City of Puyallup
Building
REVIEWED
FOR
COMPLIANCE

SITE PLAN - TACO TIME
PUYALLUP, WA

PROJECT
TACO TIME | EAST MAIN PUYALLUP

INSTALL LOCATION
1115 E MAIN, PUYALLUP 98372

7

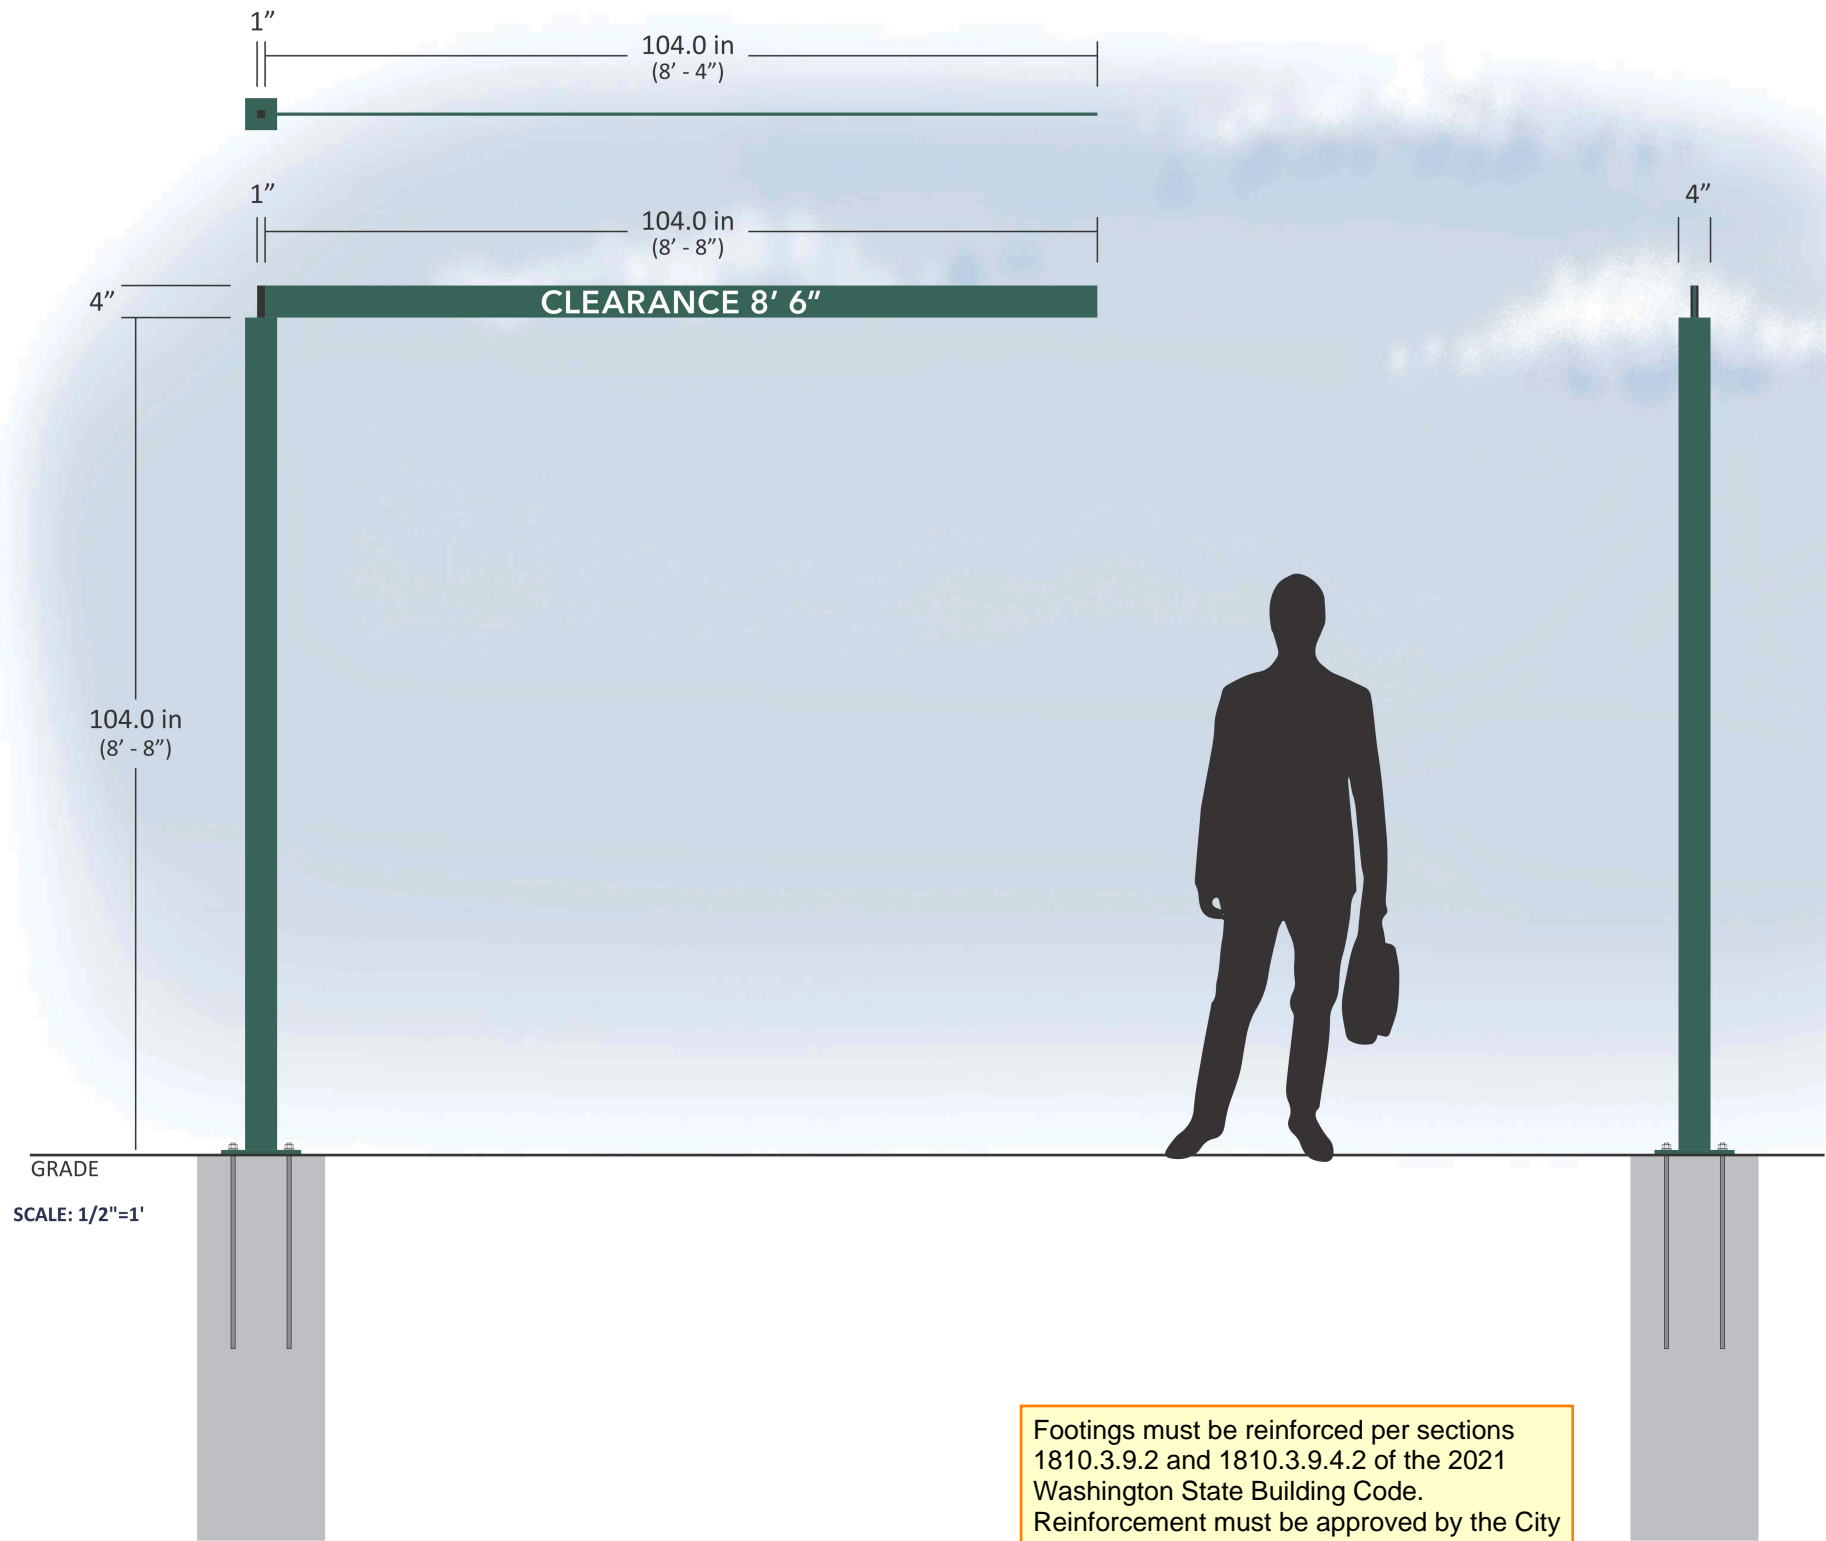
Prior to installation:
Review anchor product's ICC-ES Report and install the product per the report. If the report states special inspection(s) are required - the final special inspection report must be on site during City inspections.

Footings must be reinforced per sections 1810.3.9.2 and 1810.3.9.4.2 of the 2021 Washington State Building Code. Reinforcement must be approved by the City Inspectors prior to covering.
